City of Canby

DATE: June 25, 2021 for June 28, 2021 Planning Commission Meeting
TO: Planning Commission
FROM: Ryan Potter, AICP - Senior Planner
RE: Supplemental Materials – June 28, 2021 Meeting

Attachment 2 Agency Comments – Clackamas County (Canby South)

TO: Ryan Potter, City of Canby
FROM: Kenneth Kent, Development Engineering
DATE: June 24, 20219
RE: DR 21-20 Canby South
41E03 00100 and 00103

A
G1.0 OVERALL SITE PLAN
1" = 60'-0"

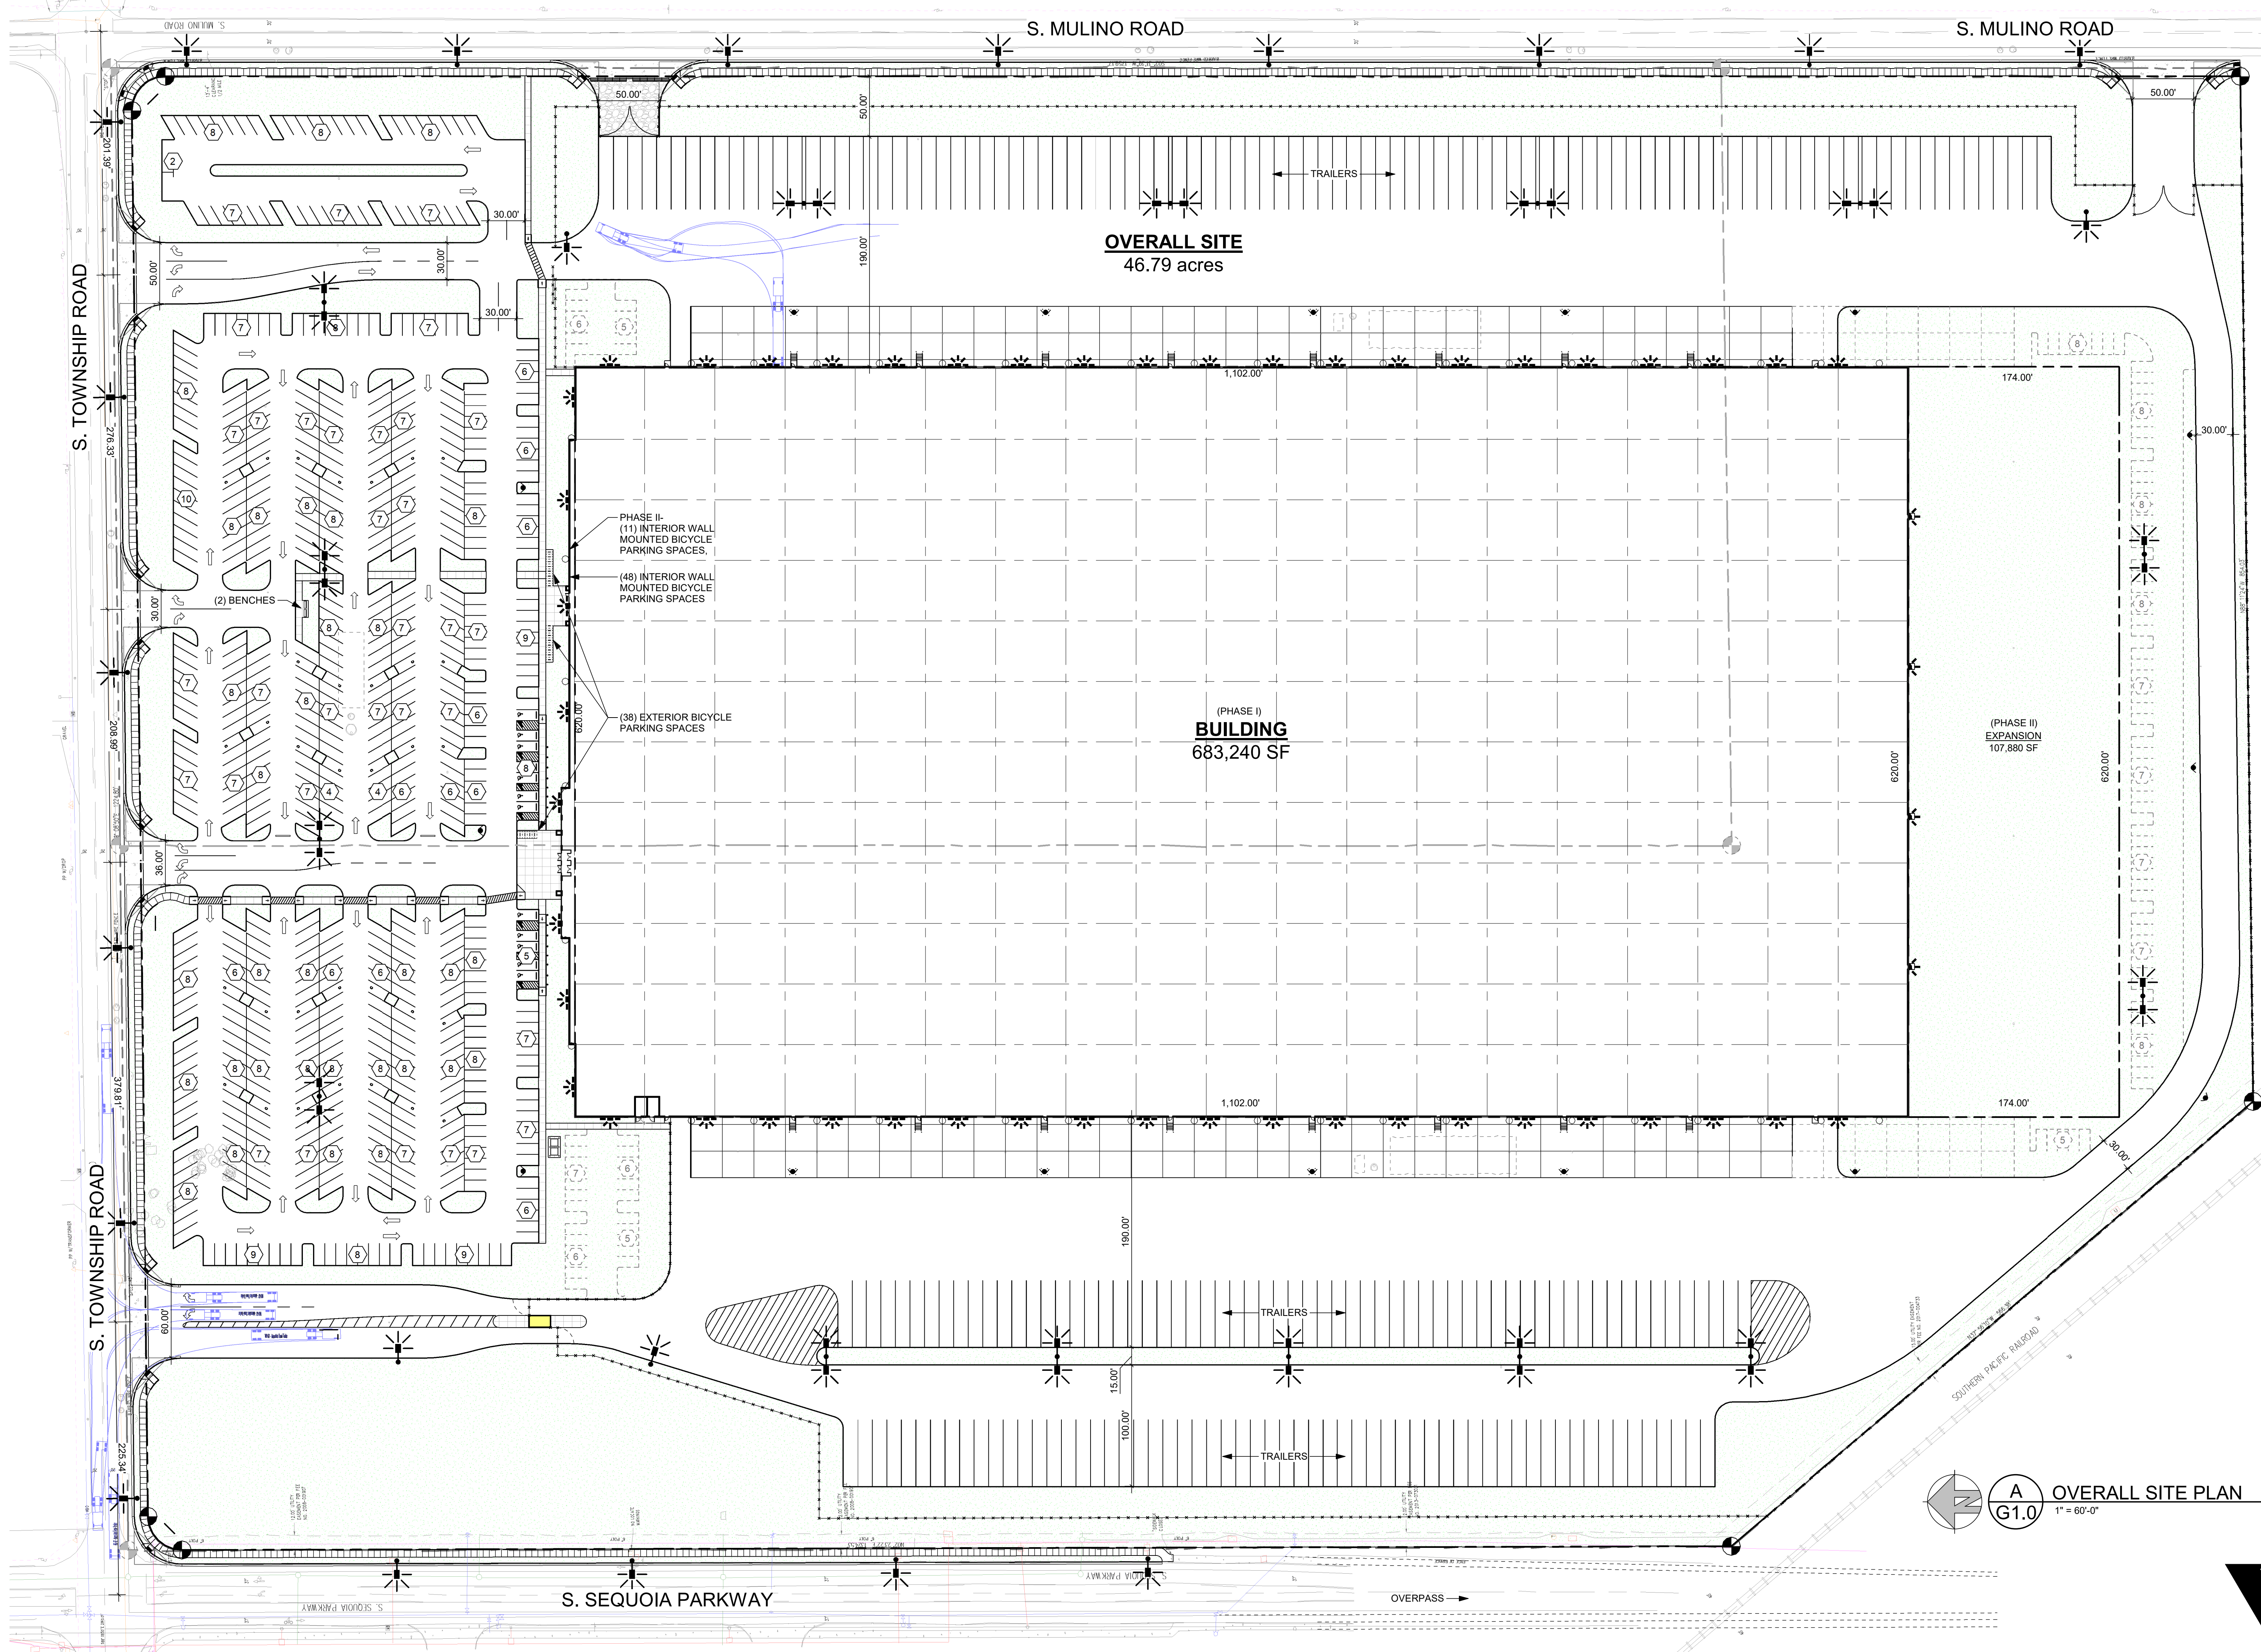
- **Bike Parking Clarification:**
The Bicycle Parking Calculations summarized on the cover sheet of the plans have been revised to clarify the number of bike spaces that will be provided with each phase of development. As illustrated on the site plan, a total of 86 bike racks are being provided with the initial phase of development with an additional 11 racks provided with the 2nd phase of development. The bike parking count meets and/or exceeds the development standard of 1/1000sf and 0.1/1000sf bike space for office and warehouse use.

- **Auto Parking Clarification:**
The Auto Parking Calculations summarized on the cover sheet of the plans have been revised to clarify the number of auto parking spaces that will be provided with each phase. As illustrated on the site plan, a total of 637 auto parking spaces are being provided with the initial phase of development with an additional 108 spaces to be provided with the 2nd phase of development. Although these parking counts do not meet the development standard, the proposed parking is more than sufficient to accommodate the parking needs of the E-
